**Re: Agnico Eagle's response to CIRNAC Comments regarding the Whale Tail (2AM-WTP1830) –60-Day Notice
Whale Tail Emulsion Plant**

- Crown-Indigenous Relations and Northern Affairs Canada – December 20, 2021: Crown-Indigenous Relations and Northern Affairs Canada's (CIRNAC's) Review of the Commission and Construction of Whale Tail Emulsion Plant Proposal; Submitted by Agnico Eagle Mines (AEM) for Type A Water Licence No. 2AM-WTP1830

TITRE / TITLE
AGNICO EAGLE - DIVISION AMARUQ
446 - EMULSION PLANT PAD
230 - GENERAL EARTHWORKS
DETAIL AND SECTIONS

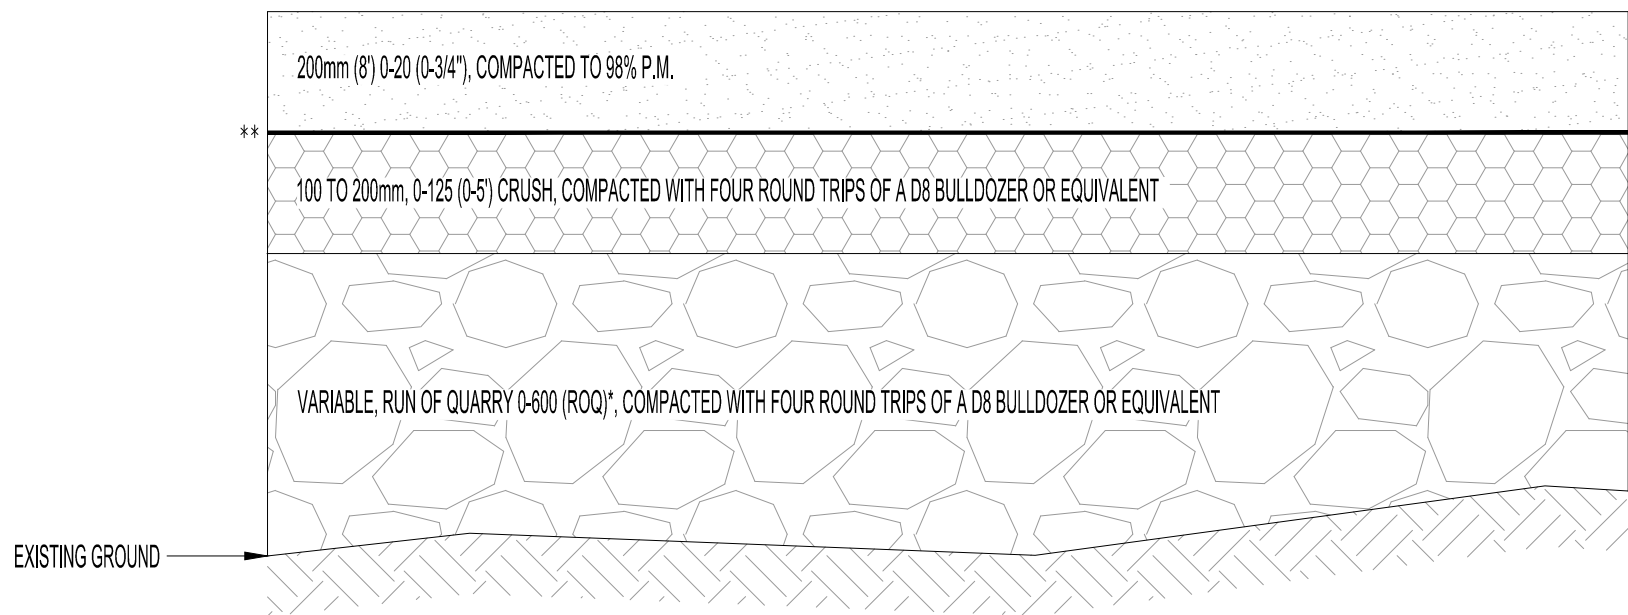
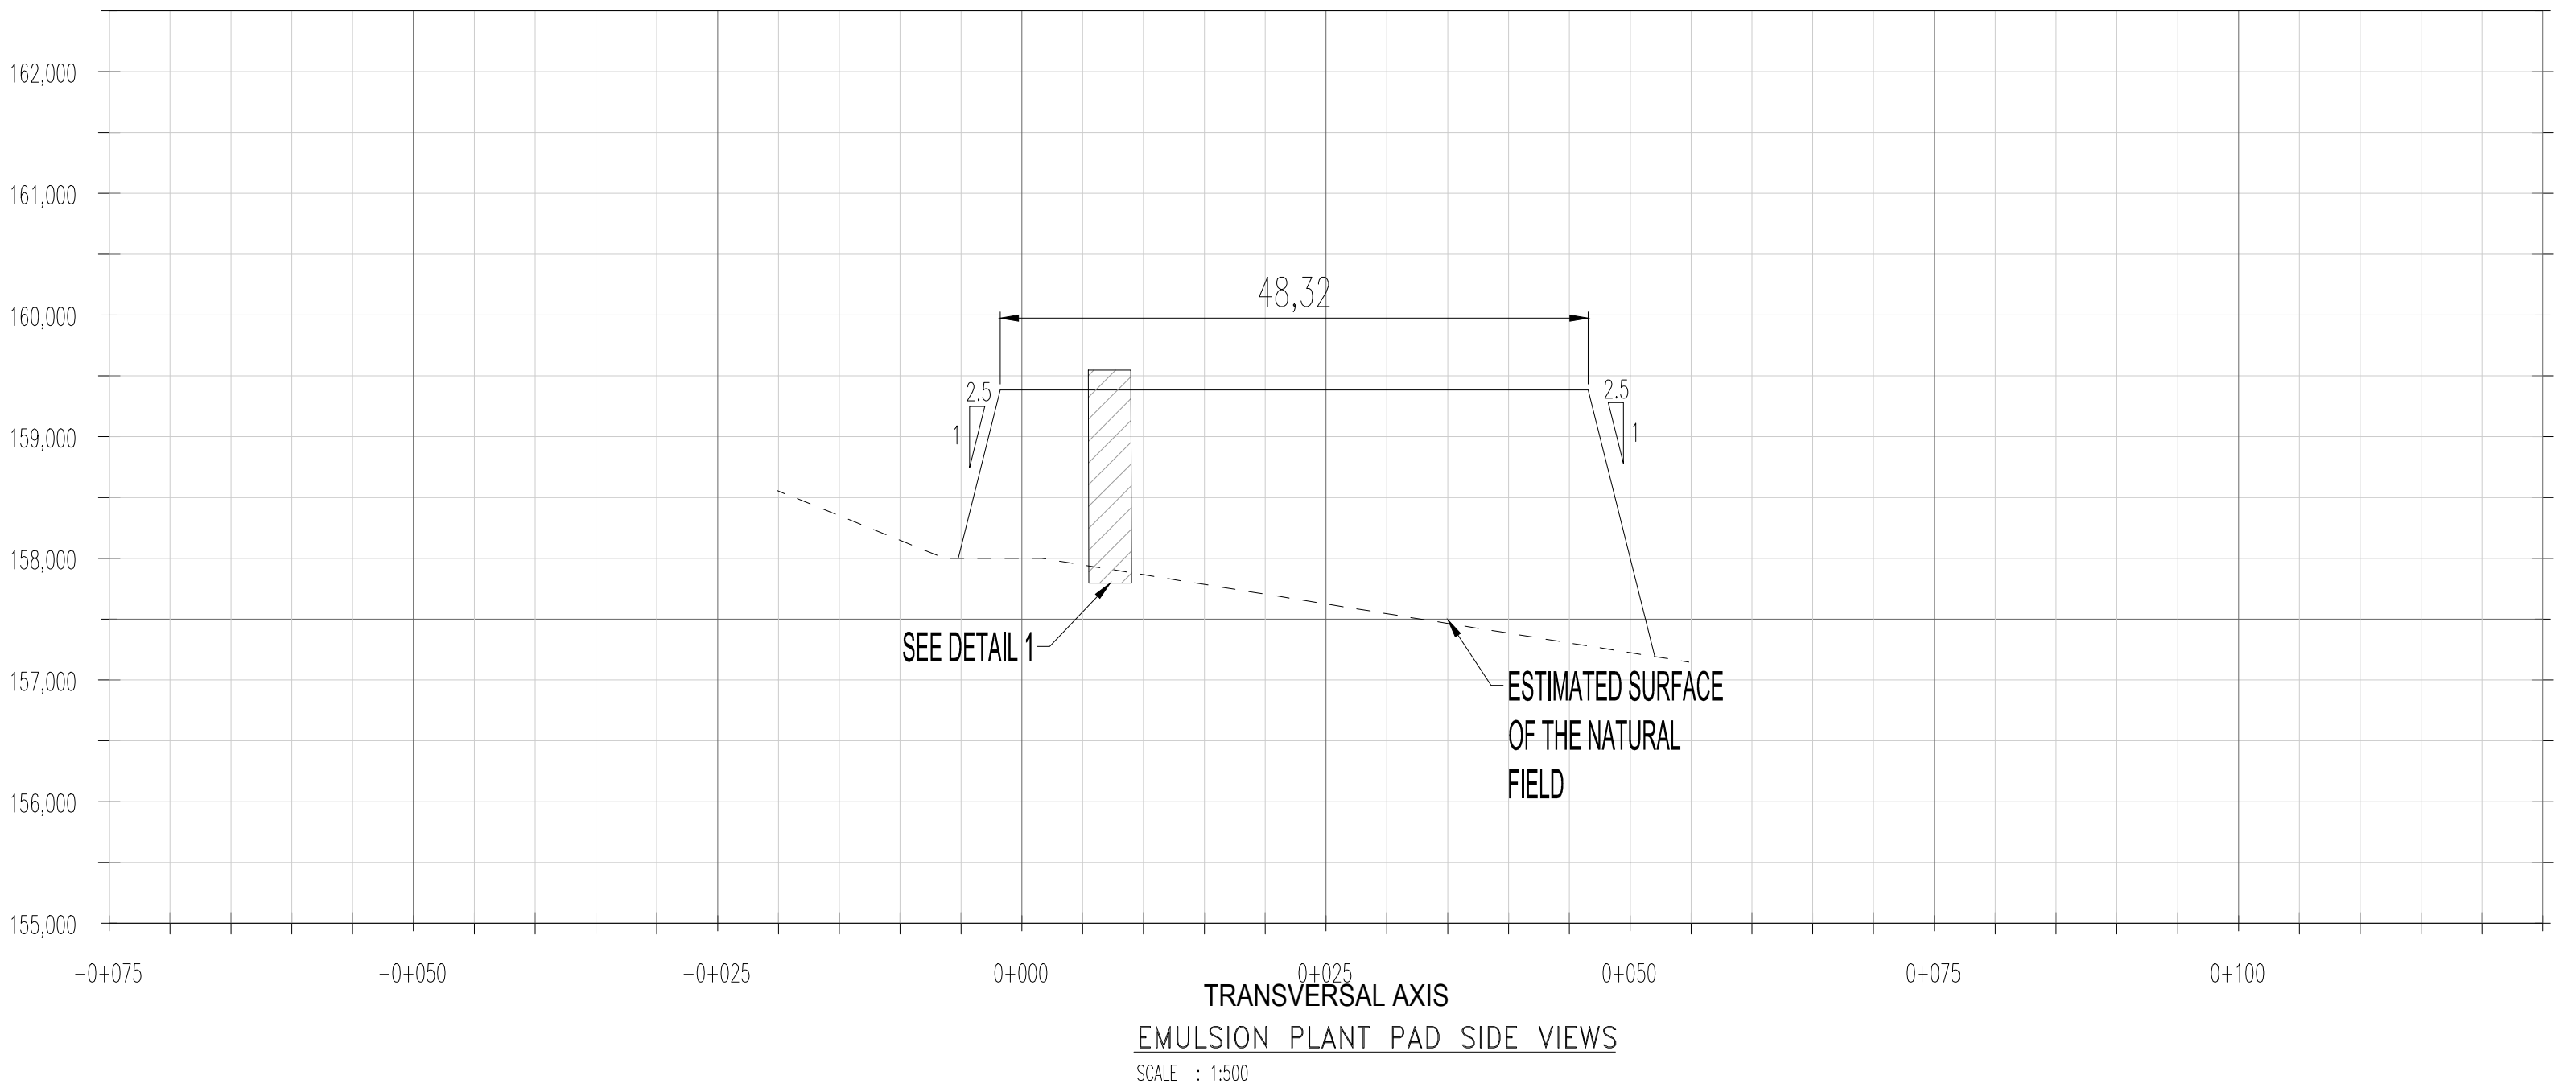
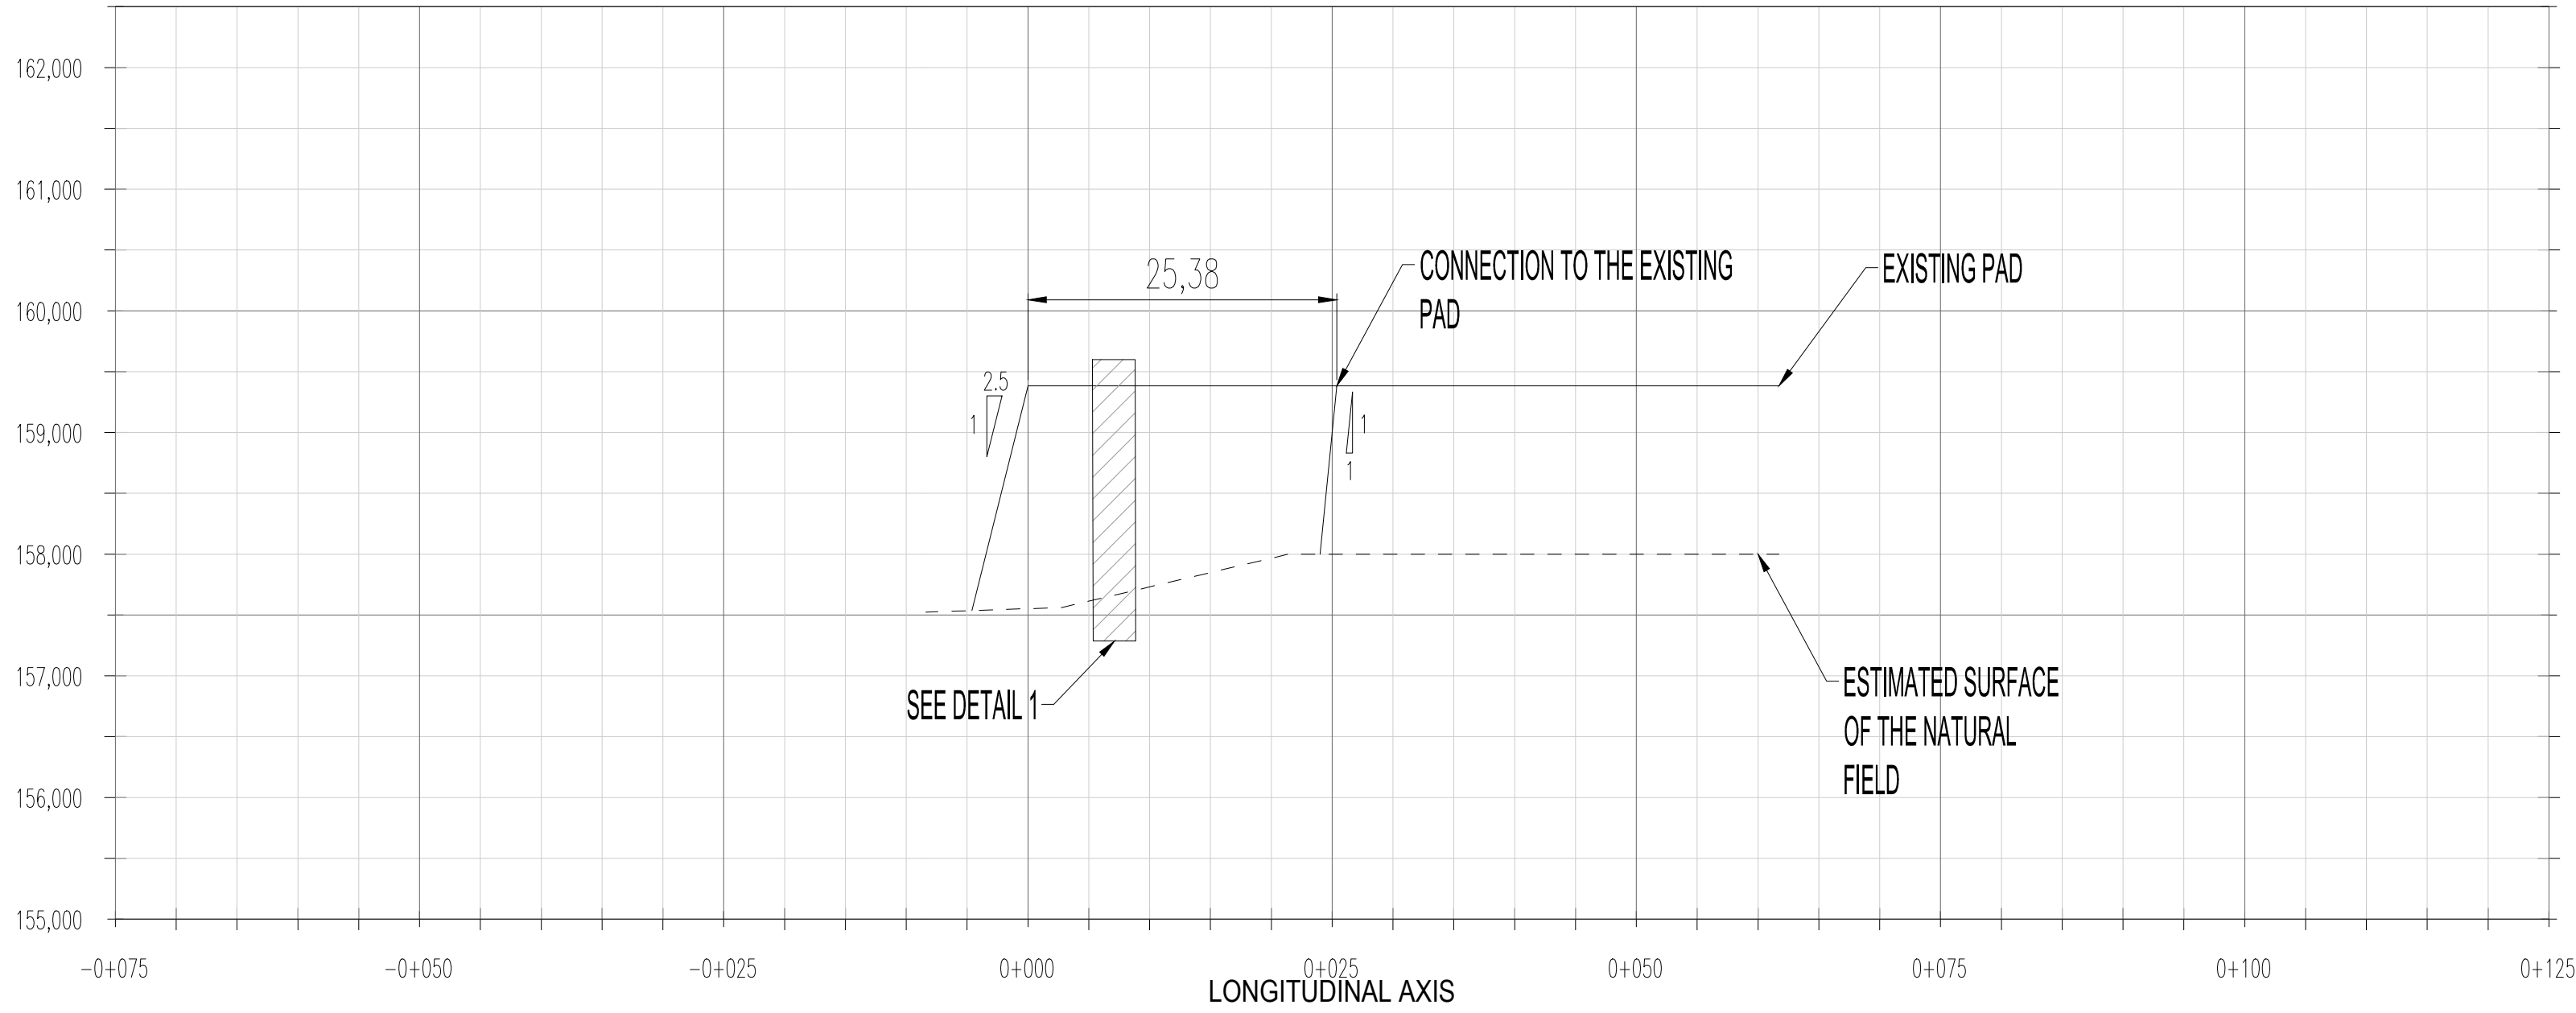
Comment: Having a clearer understanding of the foundation on which AEM plans to erect structural items anticipated to support the Emulsion Plant Super-Structure, is critical to understanding the anticipated impacts that the project would have on ground water.

CIRNAC has identified that the engineering drawings attached to Agnico Eagle's notification letter to the NWB for the proposed Whale Tail Emulsion Plant construction did not provide information on the design criteria. Ideally, these design criteria are supposed to include a description on how all the indicated foundations (i.e. hopper foundation and crane foundation), structural stand and 6" precast concrete; are originally planned to be put in place. CIRNAC is also identified that the provided grading plan in the notification letter, is not for construction.

Recommendation 2: CIRNAC recommends that AEM should provide a detailed foundation plan that clearly specifies all the structural items anticipated to support the Emulsion Plant super-structure in addition to an IFC version of the provided grading plan.

Engineering drawings 61-446-230-002 & 61-446-230-003 has been updated will additional information. It's important to point out that the proposed foundation design is similar to the one supporting the existing Meadowbank Emulsion Plant and no issue has been observed over the last 12 years of operation.

Moreover, the building is not anticipated to have any effect on groundwater as it will be built on land. It's expected that the addition of the filling material required to build the foundation would increase the elevation of the active layer. Instead of the active layer being located only into the overburden, this one will be move up into the foundation. As the foundation is a relatively small surface area compared to the size of the hydrogeological modeling domain used for the Whale Tail Expansion Project, it's not expected that the construction of the foundation will result in any change into the groundwater flow regime.
